- 3 APL2021/0003 (S83 Review of LDA2020/0185)**  
**19-21 Myra Avenue, Ryde**  
**Multi dwelling housing development containing 5 dwellings (2 x 5 bed and 3 x 3 bed) as well as strata subdivision.**

### **City of Ryde Local Planning Panel Report**

<b>DA Number</b>	APL2021/0003
<b>Site Address &amp; Ward</b>	19-21 Myra Avenue, Ryde NSW 2112 Lot A Deposited Plan 408670 and Lot 11 Deposited Plan 12555 Central Ward
<b>Zoning</b>	R2 Low Density Residential
<b>Proposal</b>	Multi dwelling housing development containing 5 dwellings (2 x 5 bed and 3 x 3 bed) as well as strata subdivision.
<b>Property Owners</b>	Robert De Nicola and Patricia De Nicola
<b>Applicant</b>	Robert De Nicola and Patricia De Nicola
<b>Report Author</b>	Kimberley Kavwenje
<b>Lodgement Date</b>	5 July 2021
<b>No. of Submissions</b>	Four (4) submissions objecting to the development
<b>Cost of Works</b>	\$2,476,320.00
<b>Reason for Referral to LPP</b>	Section 8.5 Environmental Planning and Assessment Act 1979. Development Application was determined by the Local Planning Panel.
<b>Recommendation</b>	<b>Confirmation of Refusal</b>

**Figure 11** Flood Risk Map overlaid on the Site Plan

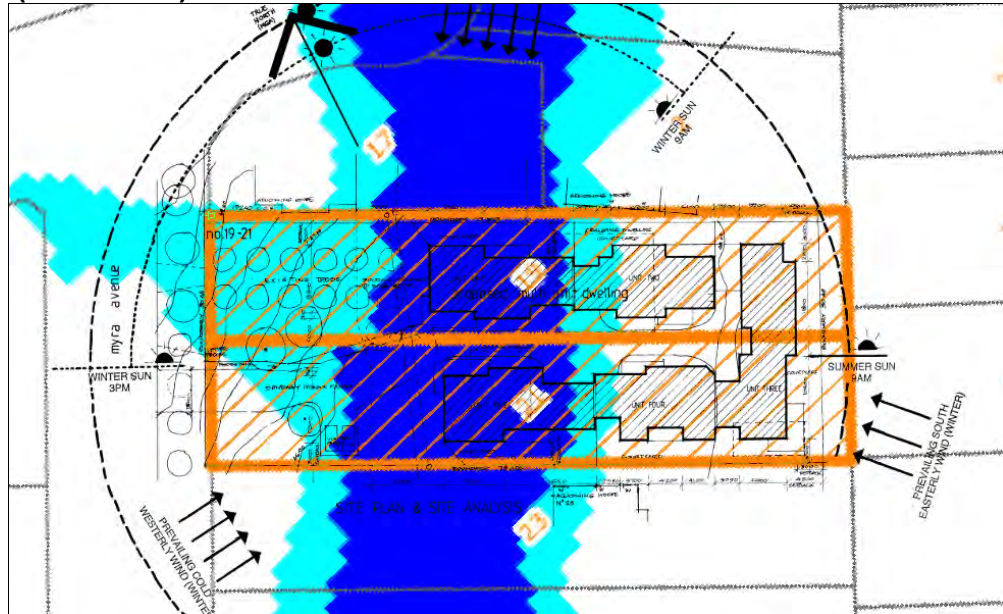
- Flood levels must be used as per flood certificate issued by City of Ryde. As per Council investigations, the proposed levels for the development does not comply with the freeboard requirements of City of Ryde ( the deck level at Unit 1 is proposed below 100-year ARI level). The correct freeboard on decks to (non-habitable areas) as per City of Ryde DCP is required to be used.

- The proposal has not demonstrated compatibility with the flood function. A significant portion of the land is mapped as being subject to medium flood risk and proposes 5 dwellings (**Figure 11**).
- The proposal due to the building footprints and associated structures will affect the flood behaviour and the development has not demonstrated that it will not result in adverse impacts upon neighbouring properties.
- The proposal has not been supported by satisfactory information.

**Figure 12** Hard stand parking space associated with Unit 4 and proximity to southern side boundary and existing dwelling 23 Myra Avenue

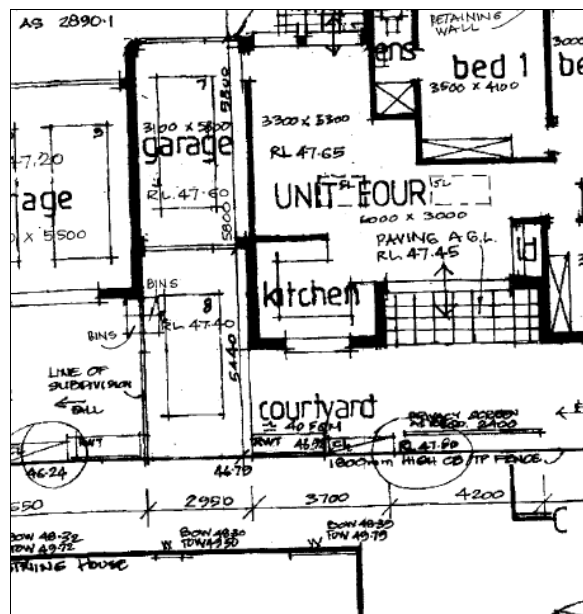
The proposed tandem parking space associated with Unit 4 includes 800mm of fill and sited adjacent to the southern side boundary. The space is RL47.40 and aligns with the openings within 23 Myra Avenue (**Figure 12**). The opening has a sill height of RL48.3 and a lintel height of RL49.5. The sight line available from the parking space would correlate with the existing opening.

The tandem parking space associated with Unit 4 abuts the southern side boundary and includes 800mm of fill. The space is at RL47.40 and aligns with the openings within 23 Myra Avenue (**Figure 12**). The opening has a sill height of RL48.3 and a lintel height of RL49.5. The sight line available from the parking space would correlate with the

**Figure 13** Southern elevation of Unit 1 and new openings

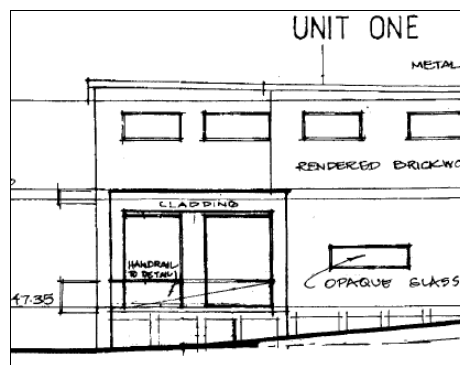
Concern is held regarding the proposed separation distances of the decking associated with the living rooms for Units 1 and 5. Unit 5 relies upon this decking and associated windows within the northern elevation for solar amenity. The Unit also contains decking within the southern elevation and is overshadowed throughout the day. This decking does not perform as ancillary area to facilitate the entrance to the dwelling only, as it is relied upon for residential amenity and the separation distance and alignment of the openings within 7.3 metres (**Figure 13 and 14**) means there is a resultant privacy impact between dwellings.

**Figure 14** Northern elevation of living room windows for Unit 5

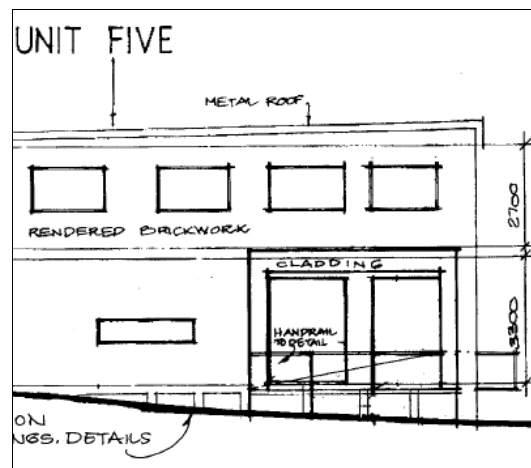
The submitted shadow diagrams (**Figure 15**) demonstrate the POS of Units 4 and 5 will not receive the required solar access. Unit 5 provides for large openings within the northern elevation associated with the living room (**Figure 14**) which receives partial sunlight at 3pm. Hourly shadow diagrams have not been provided to demonstrate the extent of overshadowing from Unit 1 to these openings at 12 noon. However, given the height and separation distance there will be impact from 12 noon.

Figure 15 Shadow diagrams on 21 June

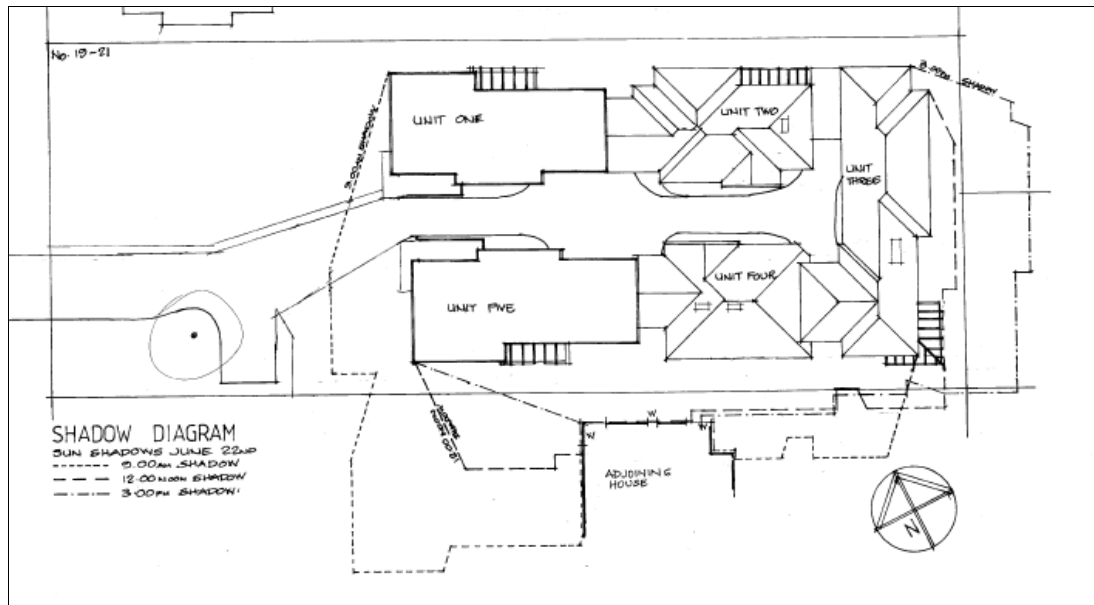
The submitted shadow diagram does not show the shadow cast from the proposed Unit 1 and 2 at 12noon and 3pm. These dwellings are located to the north of the proposed Unit 3, 4 and 5.

impacts. Whilst the proposal has been amended to provide for skylights within Units 2, 3 and 4. No further shadow diagrams have been submitted including hourly diagrams and information to quantify the amount of solar access received. This is maintained as a reason for refusal.

**Figure 1** Vehicle manoeuvring for Unit 3

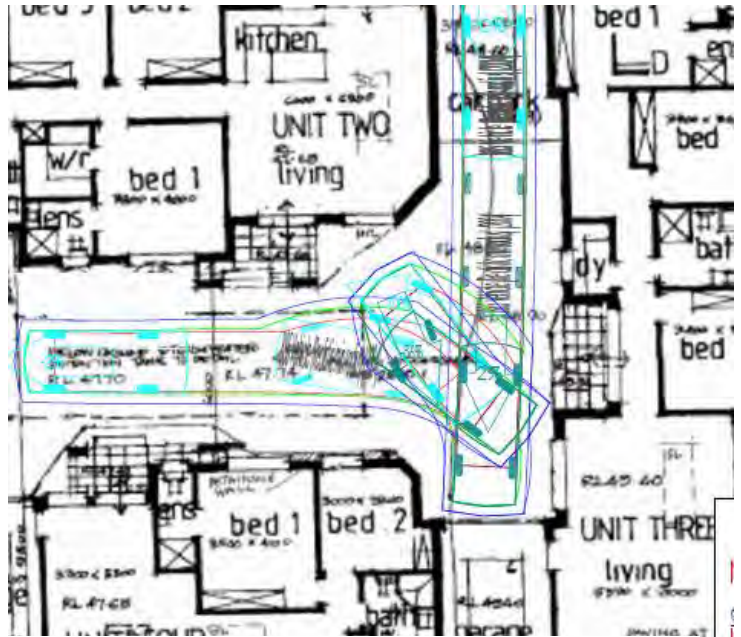
Control (a) requires vehicles to enter and leave in a forward direction and control (e) requires vehicles to be able to enter and leave parking space in a single 3-point turn. The application has been supported by vehicle manoeuvring diagrams for some but not all parking spaces. The swept path diagram for unit 1 does not show entry/exit to all the parking spaces. These swept path diagrams indicate reverse entry to the garages which is not desirable. The entry and exit to some of the garages (Unit 3) require more than a three-point turn which is unacceptable (**Figure 16**). LDA2020/185 was refused on the basis of insufficient information provided in regard to vehicle manoeuvring (Reason 4), the information has been provided and now demonstrates the development is non-compliant and this forms a reason for refusal.

**Figure 17** Landscaping proposed in association with Unit 4

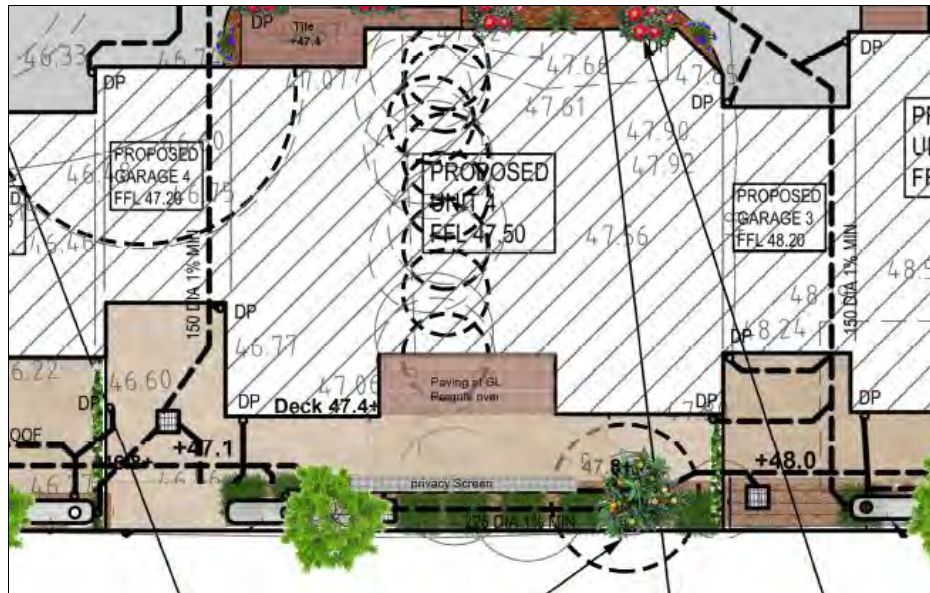
existing opening. The proposal does not include any screen planting (**Figure 17**) or other mechanism to ameliorate the impact.

**Figure 12** Shadow diagrams on 21 June

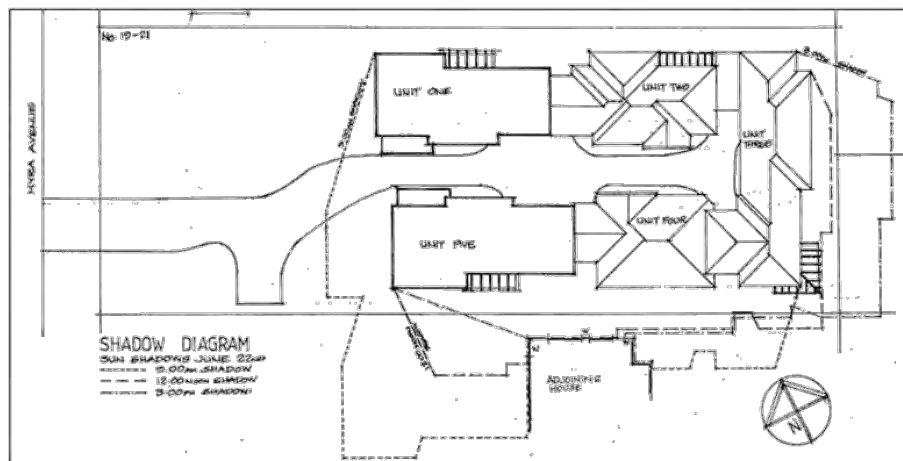
The proposal is non compliant with control (c) of Section 3.6 and control (b) of Section 3.9 in that 50% of the private open space does not receive the required solar access of 2 hours. For private open space on adjacent properties that are already non-compliant, sunlight must not be further reduced by more than 20%. The submitted shadow diagrams depict the 9am, 12pm and 3pm shadow impact in midwinter (**Figure 12**).

The submitted shadow diagrams indicate that the private open space of the southern oriented units, being Unit 4 and Unit 5, will each receive non-compliant solar access during midwinter. Unit 5 contains a western and northern elevation associated with the living room receives reasonable solar access and is acceptable despite the private open space not receiving compliant solar access.
